Project Details:
Dalgise
Monkstown

Drawing Title:
Proposed GA Plans + Elevations + Sections -
Block J

Status:	Purpose of Issue:	Revision:
P01	PLANNING PERMISSION	P02
MKS-RAU-J-Z-DR-AR-100

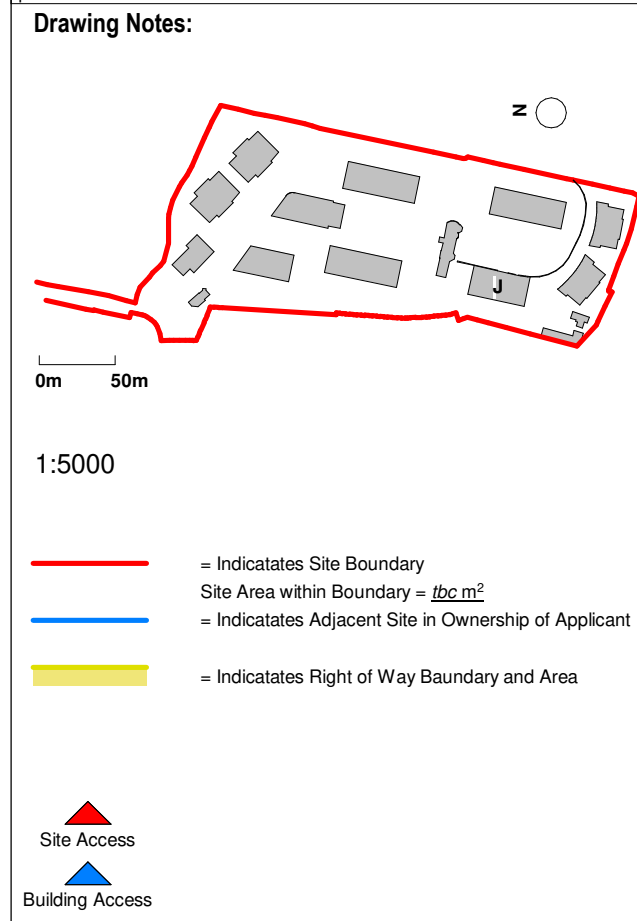
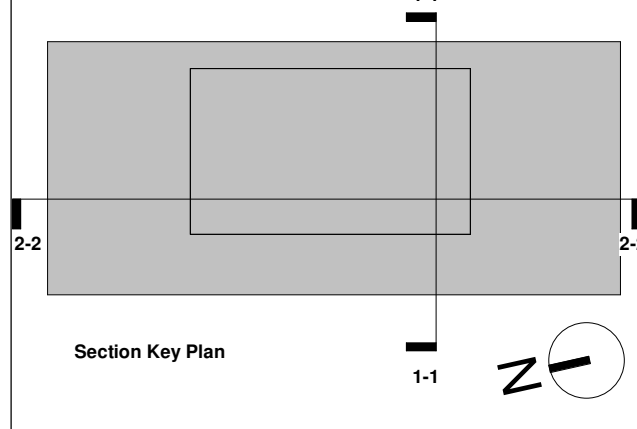
- J1. New Secondary Entrance added to Block J.
- J2. 3 Bed Apartment changed to 2 bed Apartment
